Product Change Notification: E-19-003911

250 FASTON RECEPTACLE SERIES

synchronization for part and drawing The drawings for the listed part numbers have been modified for clarification; Before: After:

Before and After

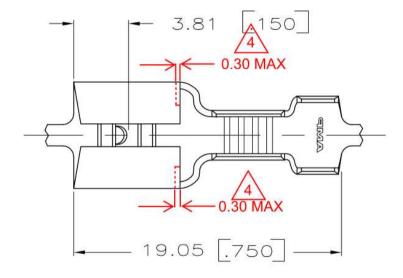
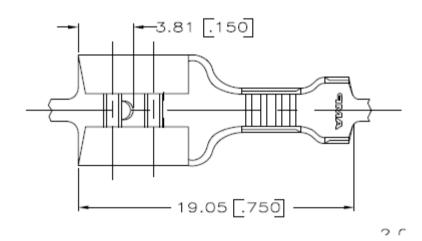
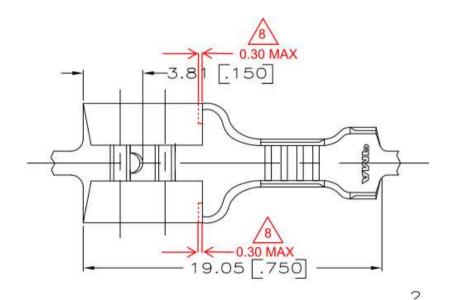
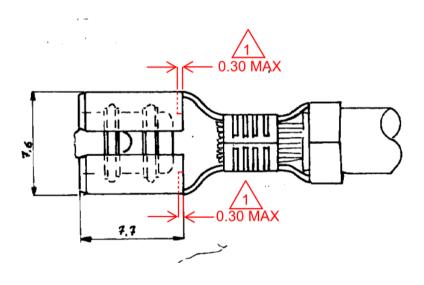
Manufacturing / Process Requirements. Dear customer, Customer drawings will be updated to add cut-off offset. the cut-off offset is allowed by 0.3mm max. This may be required for manufacturing, but will not impact the intended performance of the contact. This is only for drawings.

Cut-off offset adding
